GAS TURBINE MAINTENANCE

MS 5001 Turbine Rotor Clearances

FSR NO. _____ TURBINE NO. 296274 (05528) Dededo #2 DATE 2016.10.21

FIRST STAGE TURBINE

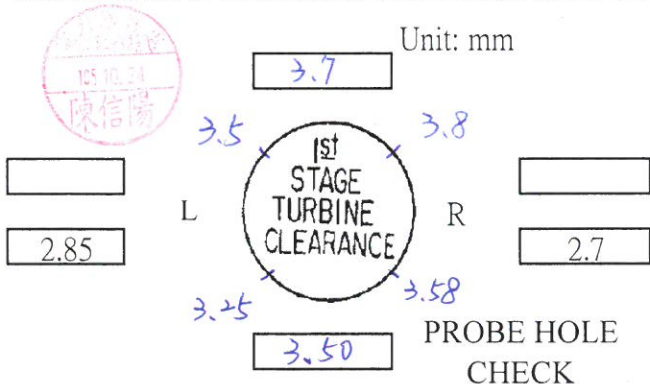
COMMENTS: - opening clearances.
 - W, IN1, IN2 are a little off but no major concern at this point
 - R is somewhat tight but no evidence of rubbing present
 - IF4 is a little open on this seal, should consider replacing seal
 by Juan Castellanos

SECOND STAGE PACKING SEALS

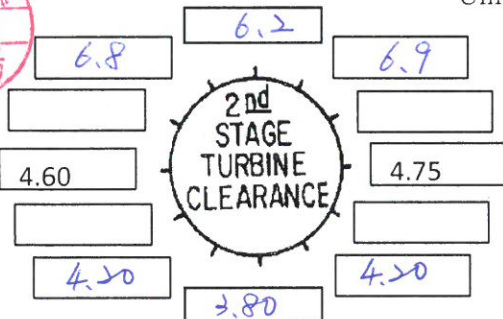
COMMENTS: -2F3 looks like the seal is broken
 -2A2 is a little open
 -Z needs to be modified at closing if necessary
 -XD+XF are off. need to be verified at closing
 JAC

SECOND STAGE PACKING SEALS

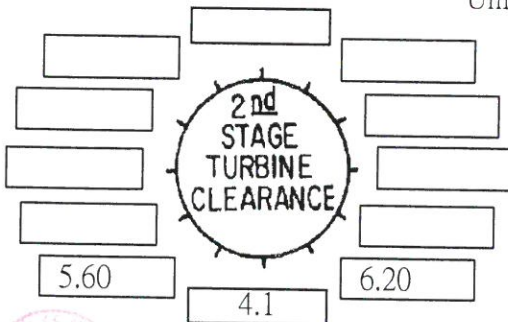
COMMENTS: -2R is not applicable on this turbine
 -2F3 the seal has wear
 -2A2 the seal has wear
 -XD close but no evidence of rubbing
 -XF open but no evidence of rubbing

SECOND STAGE PACKING SEALS

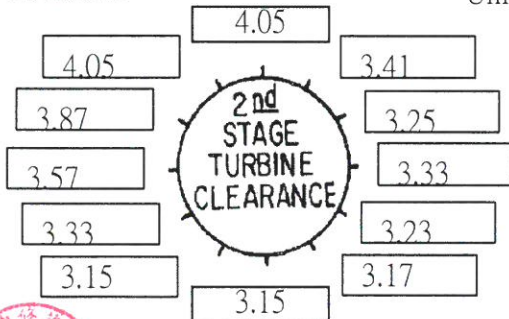
COMMENTS: *2N2 - tight, no major concern*
2F3 & 2A2 - the seal has wear
Z, IPA + IPH - clearances are off, but
no major concern on this
XD - tight, but no evidence of rubbing

FIRST STAGE NOZZLE

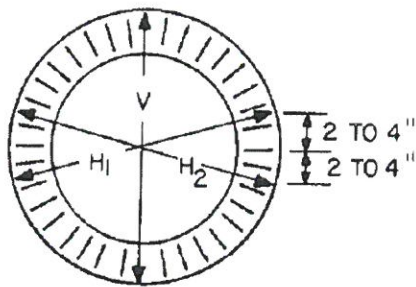
COMMENTS: - Visual and NDT inspections are reported on the NDT reports (separate)
- Ellipticity is good. Spec is 2.54mm max. JRC

MS5001 Series 2nd-stage Nozzle (General Conditions and Ellipticity)

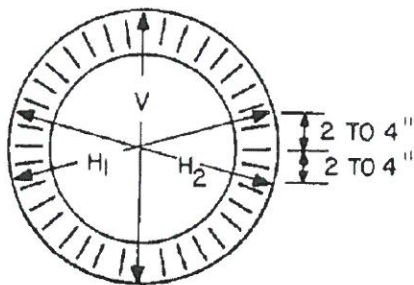
COMMENTS: - Visual + NDT inspections reported on separate NDT report.
- Ellipticity is double the specification, but the tool to measure was too short and (cont.)

(cont.) the measurements were extended using a ruler. This might have added measurements - errors. No major concern with this. *[Signature]*
 - Witnessed & Approved *[Signature]* 11/4/16
 Juan Castellanos GE

RUN OUT

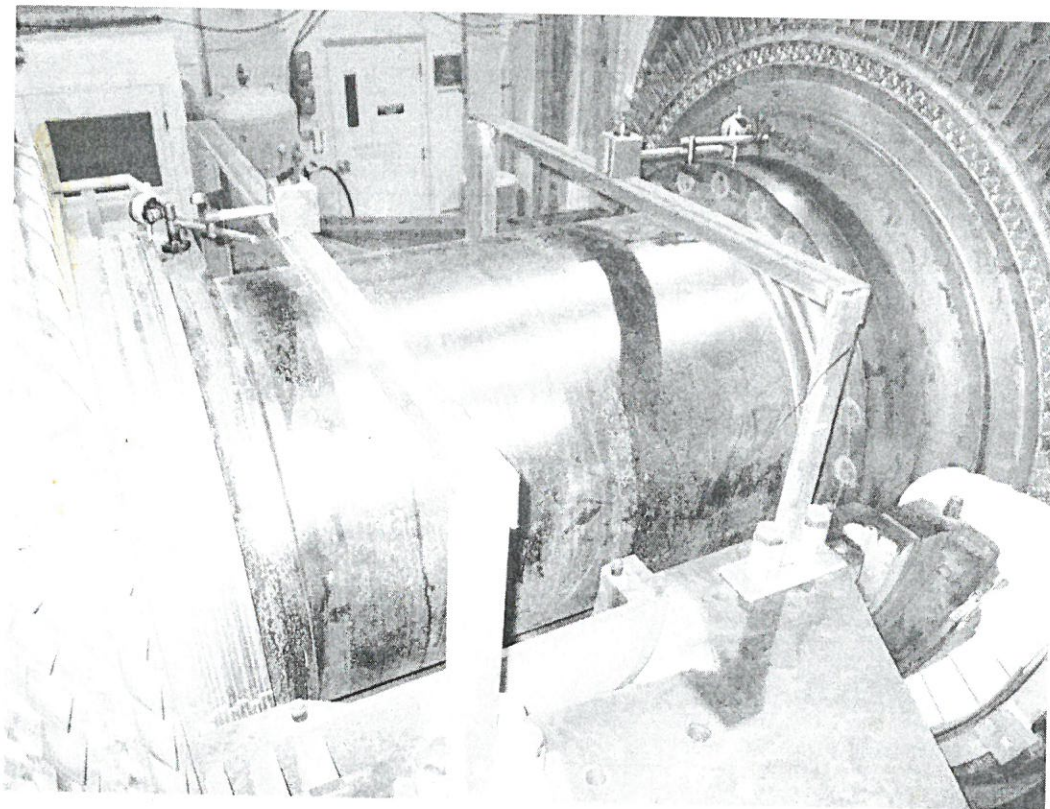
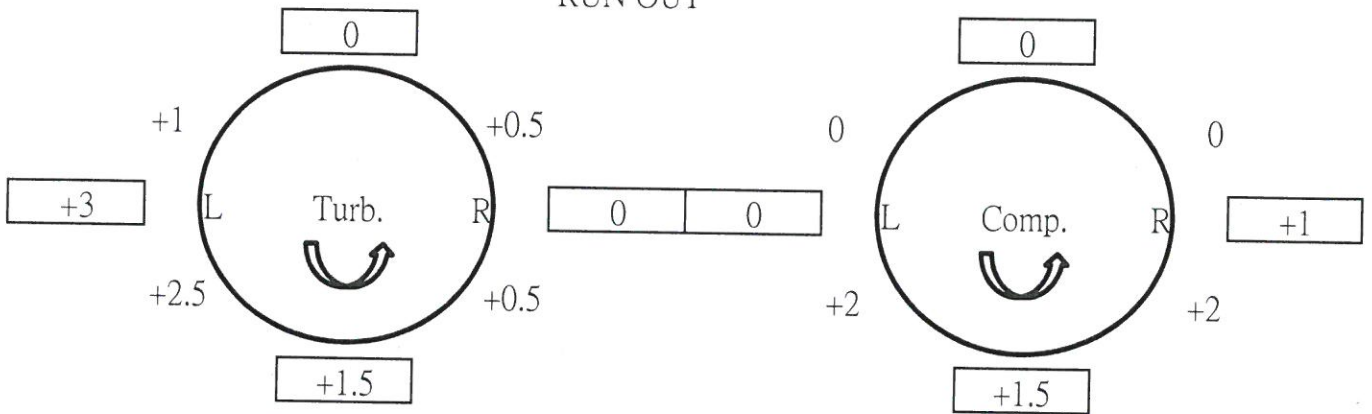
The run out is acceptable.

I.G.V.葉片間隙

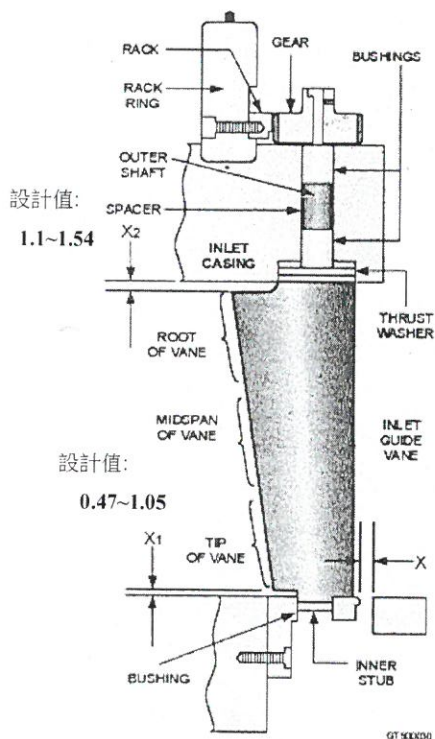
Note: X1 is bigger & X2 is shorter than spec. The thrust washers should be adjusted when the IGV blades are disassembled. No concern to run like that at the moment of 11/8/2016

I.G.V.葉片間隙

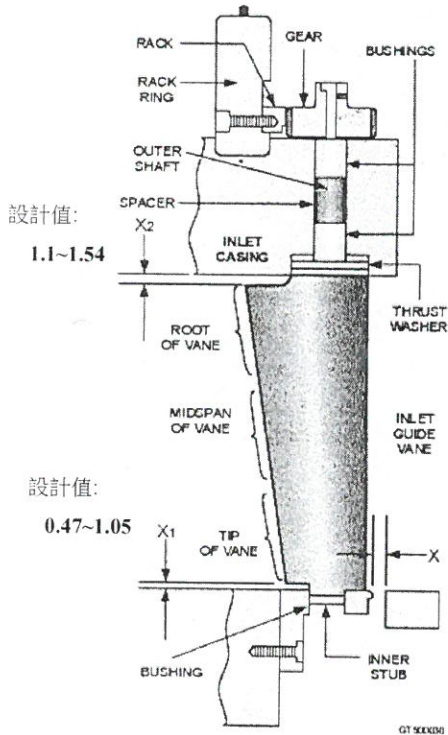
Note: X1 is bigger & X2 is smaller than spec. The thrust washers should be adjusted when the IGV blades are disassembled. No concern for run like that at the moment APE 11/8/2016

MS 5001 Seals

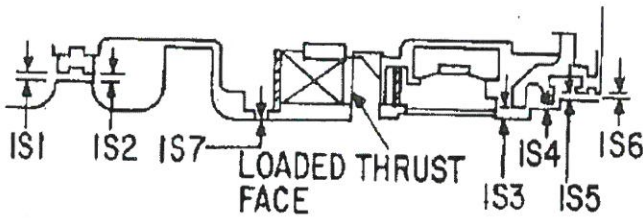
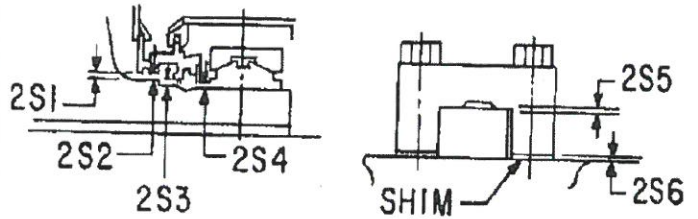
CLEARANCES		VISUAL INSPECTION		COMMENTS
	Left	Right	Condition	Disposition	
1S1	0.15	0.25			good
1S2	0.2	0.25			good
1S3	0.2	0.25			good
1S4	0.18	0.25			good
1S5	0.1	0.2			good
1S6	0.15	0.2			good
1S7	0.12	0.15			good
2S1	0.2	0.2			good
2S2	0.18	0.3			good
2S3	0.2	0.2			good
2S4	0.18	0.2			good
2S5	0	0			good
2S6	0	0			need shim thickness

Accessory Gear

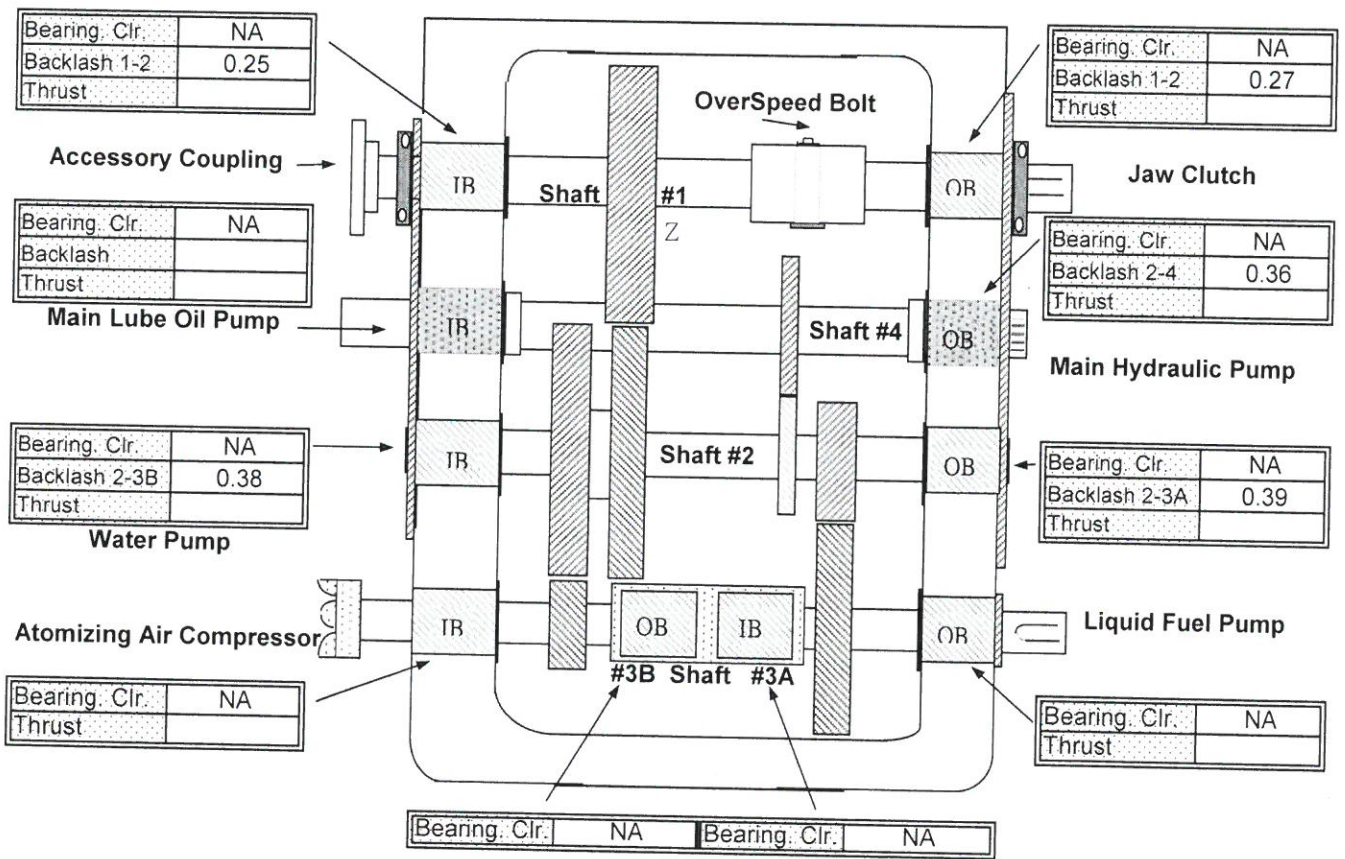
Comments:
 - Backlash is good. spec is 0.13 to 0.40 mm
 - Thrust or Brg clearance could not be obtained

Overspeed Bolt and Trip Assembly

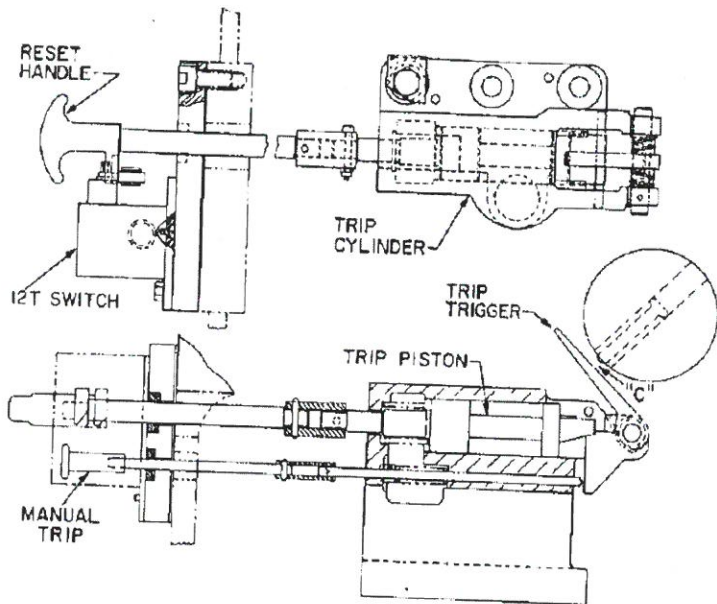
COMMENTS: *- The bolt was in good condition & stacked properly*
- The clearance is high by 0.13mm. No major concern here. APC
